Office Action Summary

09/677,870

CHOI ET AL.

DETAILED ACTION

FIG. 6

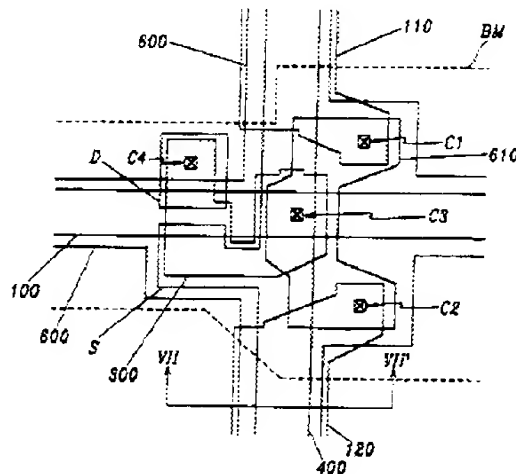
As to claims 1 and 2, Kim discloses in the third embodiment, Figures 6 and 7, (col. 6, line 35 through col. 7, line 5), a thin film transistor substrate in a liquid crystal display provided with a data line, 400, for applying a data signal, a gate line, 100, for applying a gate signal, and a transparent pixel electrode, 600, for driving a liquid crystal cell, said substrate comprising: repair lines, 110 and 120, (Applicant's gate dummy pattern) formed of the same material layer as the gate line (col. 6, lines 38-42 and col. 2, lines 10-17) so as to extend vertically from the gate line, 100, and to overlap the pixel electrode, 600, and data line 400, to compensate for misalignment occurring along the data line.

FIG. 19A

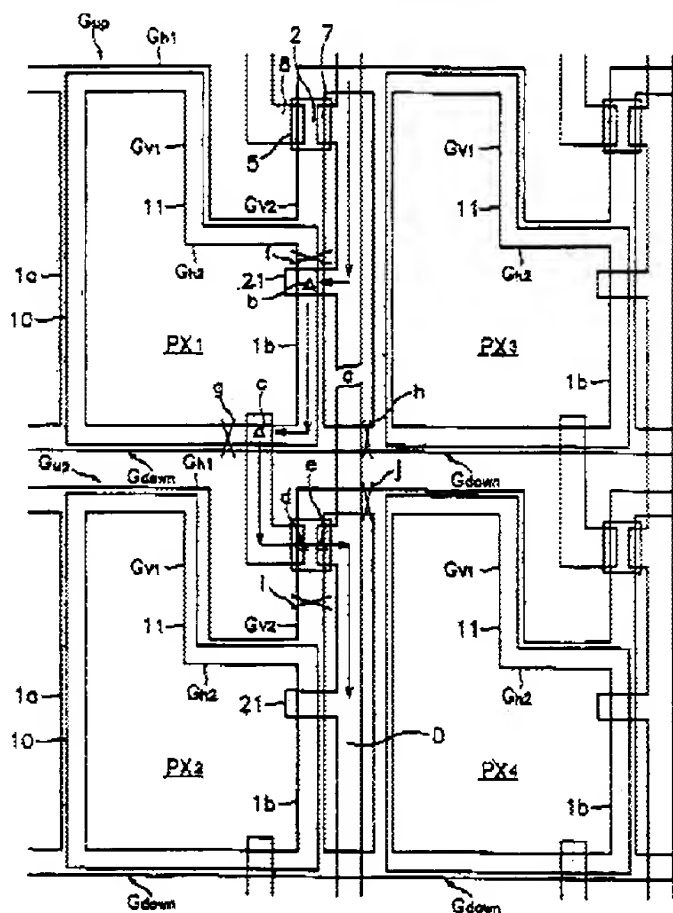
Song teaches the use of a redundant pattern that is integrated with the gate line in Figure 19A (G_{up} and G_{down} or 1a and 1b) as a redundancy electrode for electrically connecting the gate line to the broken data line (col. 17, lines 4-67, especially col. 17, lines 47-54) to effect repairs.

Song is evidence that ordinary workers in the art of liquid crystals would find the reason, suggestion, or motivation to form the gate dummy pattern in such a manner as to serve as a redundancy electrode for electrically connecting the gate line to the broken data line to effect repairs.

FIG. 26

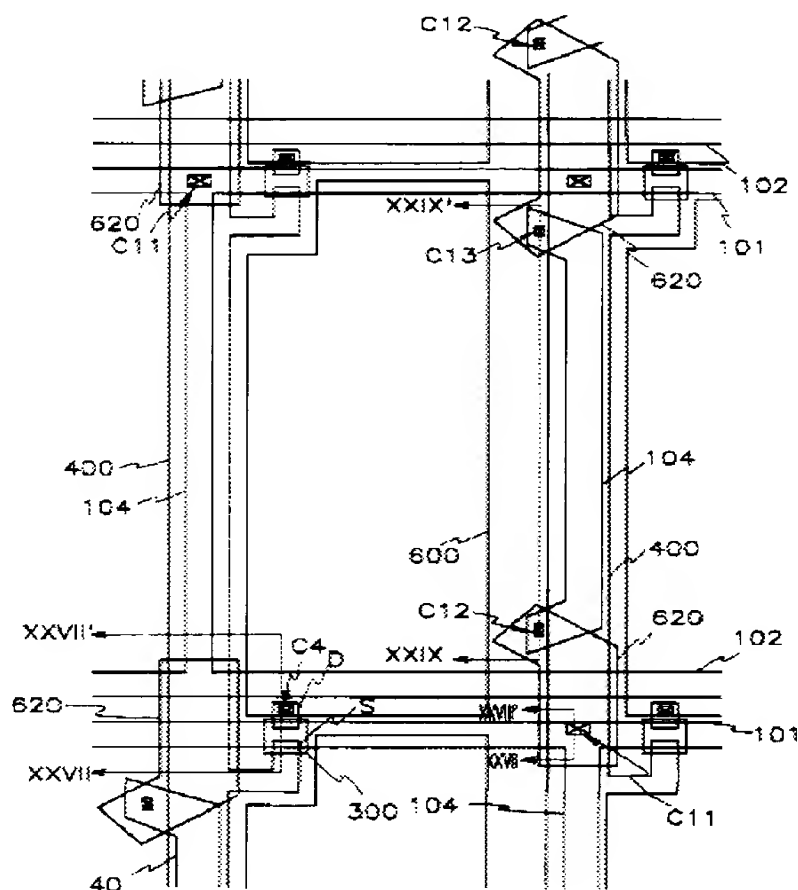
Kim teaches in Figure 26 the use of repair lines, 104, (Applicant's gate dummy pattern used as a redundancy electrode) to connect the gate line to the data line (col. 13, lines 4-17).

Kim is evidence that ordinary workers in the art of liquid crystals would find the reason, suggestion, or motivation to form holes and connect gate dummy patterns to gate lines to repair a broken data line.

FIG. 19A

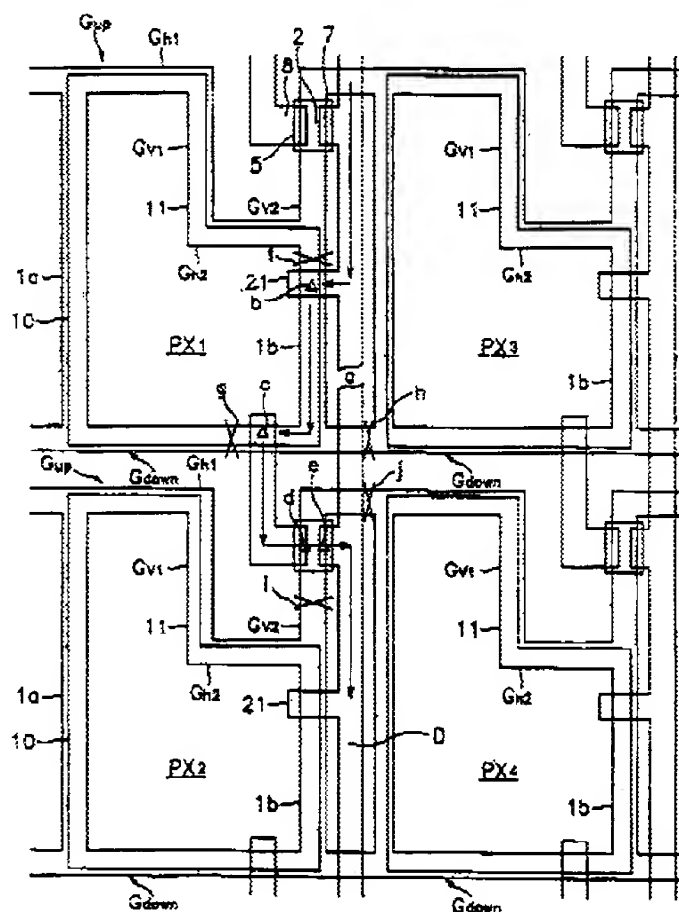
Song teaches the use of a redundant pattern in Figure 19A (G_{up} and G_{down} or 1a and 1b) as a redundancy electrode for electrically connecting the gate line to the broken data line (col. 17, lines 4-67, especially col. 17, lines 47-54) to effect repairs.

Song is evidence that ordinary workers in the art of liquid crystals would find the reason, suggestion, or motivation to form the gate dummy pattern in such a manner as to serve as a redundancy electrode for electrically connecting the gate line to the broken data line to effect repairs.

FIG. 18

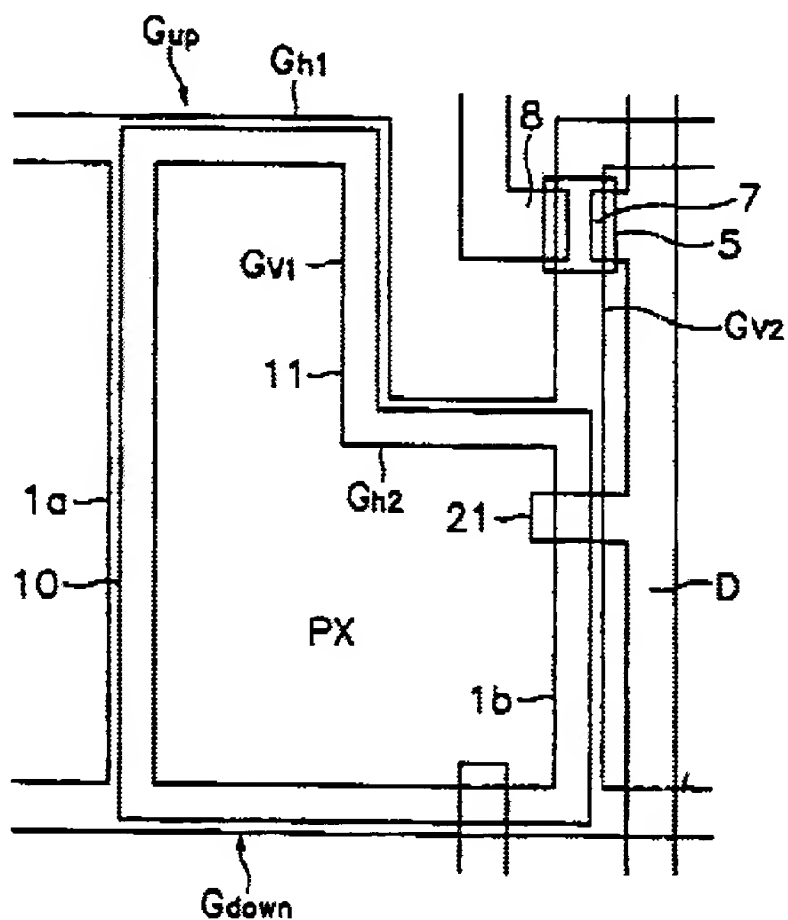
As to claims 6 and 15, Song teaches in Figure 18 a thin film transistor substrate further comprising: a storage capacitor (col. 15, lines 56-64) defined by a horizontal overlapping part, G_{H2} , between the gate line and the pixel electrode, PX. Song also teaches in Figure 18 an analogous overlapping portion, 21, of the data line, D, to permit a repair.

As to claims 7 and 16, Song teaches in Figures 18 and 19A a protrusion, 21, formed in the data line in such a manner to overlap with the intended repair site (Applicant's recess and narrowed portion of the gate dummy patterns), the structure of which would thereby shut off a light leaked between the gate dummy pattern and the gate line (col. 15, lines 42-63). Note that in considering the disclosure of a reference, it
